UNITED STATES PATENT AND TRADEMARK OFFICE

APPLICATION NO.	FILING DATE	FIRST NAMED INVENTOR	ATTORNEY DOCKET NO.	CONFIRMATION NO.
09/928,182	08/10/2001	Naoto Hirota	KANEKO.001CP1	5570
7590 01/30/2004				
Muramatsu & Associates 7700 Irvine Center Drive, Suite 225 Irvine, CA 92618			EXAMINER RUDE, TIMOTHY L	
			ART UNIT 2871	PAPER NUMBER

Office Action Summary

DETAILED ACTION

FIG. 4

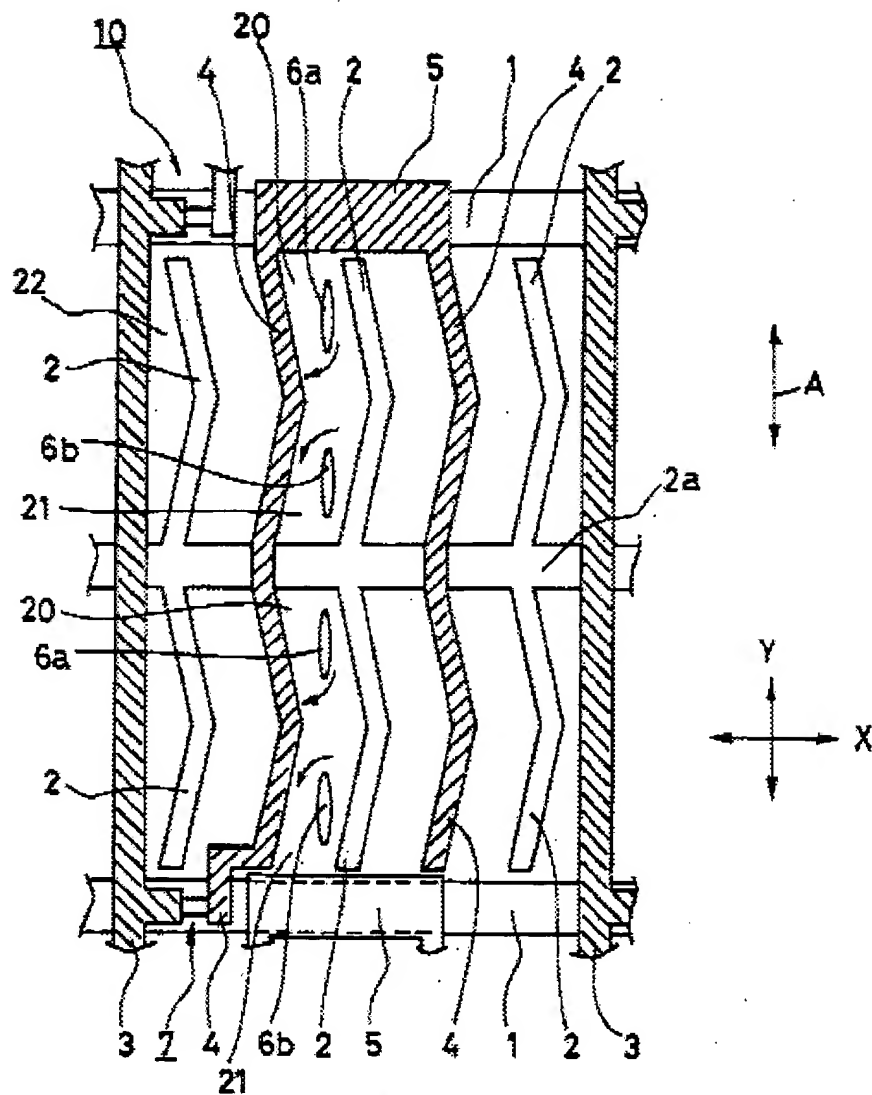
As to claim 1, Asada teaches (entire patent and especially third embodiment), a liquid crystal display device having a plurality of pixels (Figure 4), comprising: a color filter substrate (col. 1, lines 26-28); an active matrix substrate (col. 7, lines 5-34); a liquid crystal layer provided between said color filter substrate and said active matrix substrate; a plurality of video signal lines provided on said active matrix substrate; a plurality of pixel electrodes, 4, provided on said active matrix substrate; a plurality of common electrodes, 2, provided on said active matrix substrate; a plurality of switching devices, 7 (Applicant's active elements) connected to said pixel electrodes and said video signal lines; wherein each of said pixel electrodes and common electrodes is bent two or more times for each pixel to form a zigzag shape.

2. A liquid crystal display device as defined in Claim 1, wherein, when using liquid crystal of positive dielectric constant anisotropy, angles of bent of said pixel electrodes and common electrodes relative to the alignment direction of the liquid crystal are within a range from 0 to 30 degrees (col. 7, lines 5-10, col. 4, lines 11-26, and col. 6, lines 25-44).

As to claims 15 and 16, Asada discloses a liquid crystal display device as claimed, wherein said pixel electrodes and common electrodes are bent by two or more different angles for each pixel per Figure 4. Please note the angles in areas along center wiring portion, 2a, as compared with the angles midway along electrodes.

FIG. 3

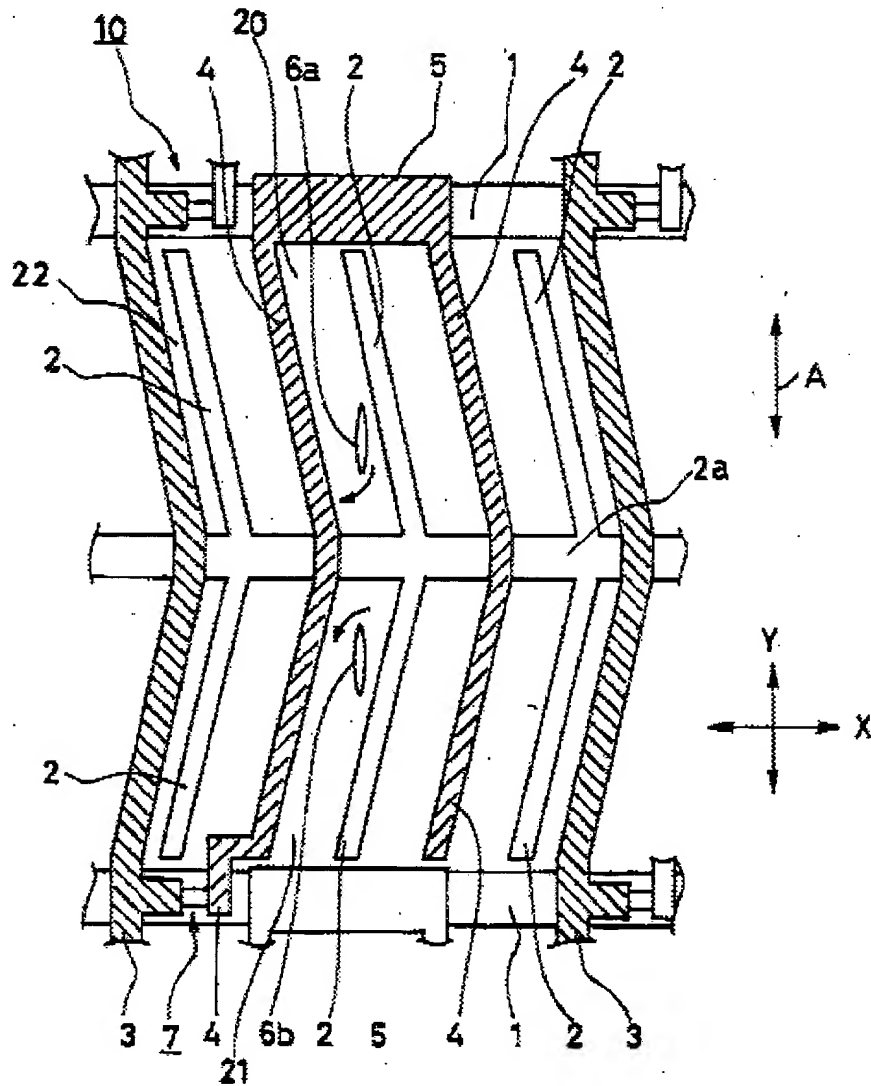
Asada teaches in the second embodiment (col. 6, line 55 through col. 7, line 4) video signal lines (Figure 3) bent parallel with the electrodes (Applicant's bent two or

more times for each pixel to form a zigzag shape) to thereby improve opening area (aperture ratio for better brightness/contrast) (col. 6, line 63 through col. 7, line 1).

Asada is evidence that ordinary workers in the art of liquid crystals would find the reason, suggestion, or motivation to add bent video signal lines, bent parallel with the electrodes (Applicant's bent two or more times for each pixel to form a zigzag shape) to thereby improve opening area (aperture ratio for better brightness/contrast).

Therefore, it would have been obvious to one having ordinary skill in the art of liquid crystals at the time the invention was made to modify the LCD of Asada's third embodiment with the bent video signal lines, bent parallel with the electrodes of Asada's second embodiment to thereby improve opening area (aperture ratio for better brightness/contrast) which would result in Applicant's bent two or more times for each pixel to form a zigzag shape.
